ADDENDUM NUMBER FIVE (5)

Project: Nancy Lopez Elementary School
1600 E. Tilden Street
Roswell, New Mexico

Date: April 12, 2024

From: PA Architects

Type 'M' (vertical install in Hall 100 & 200, total of 10)

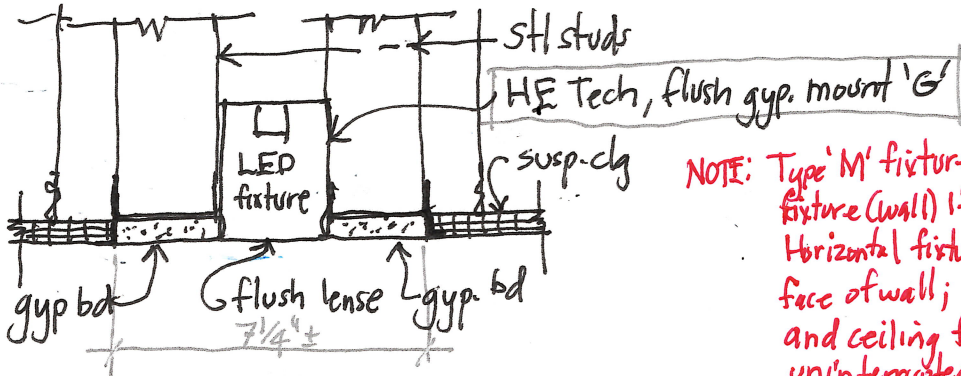
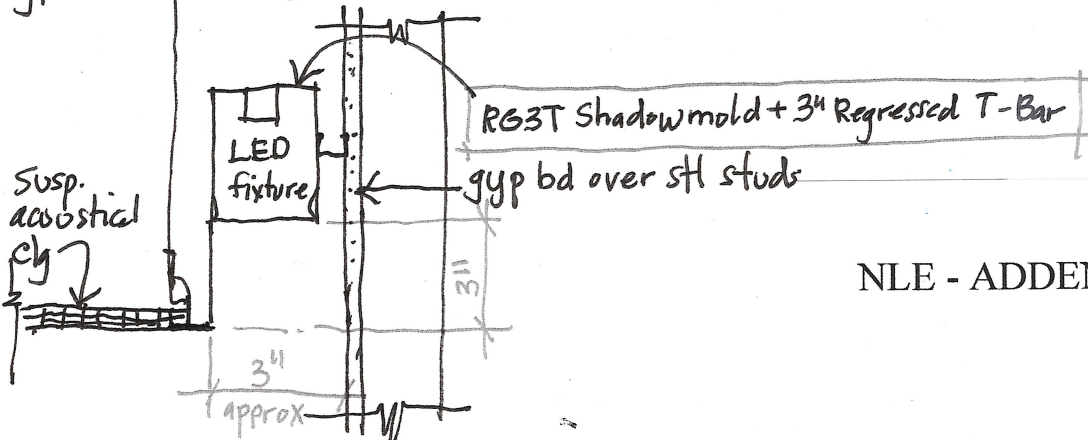
- a. See attached sketch SKA-3 for Light Fixtures Type “M” and “N” installation details.

NOTE: Type 'M' fixture installation: Vertical fixture (wall) 1'-0" up from finish floor; Horizontal fixture (ceiling) 2'-0" from face of wall; the intersection of wall and ceiling fixtures shall be uninterrupted (no gap) for continuous appearance.
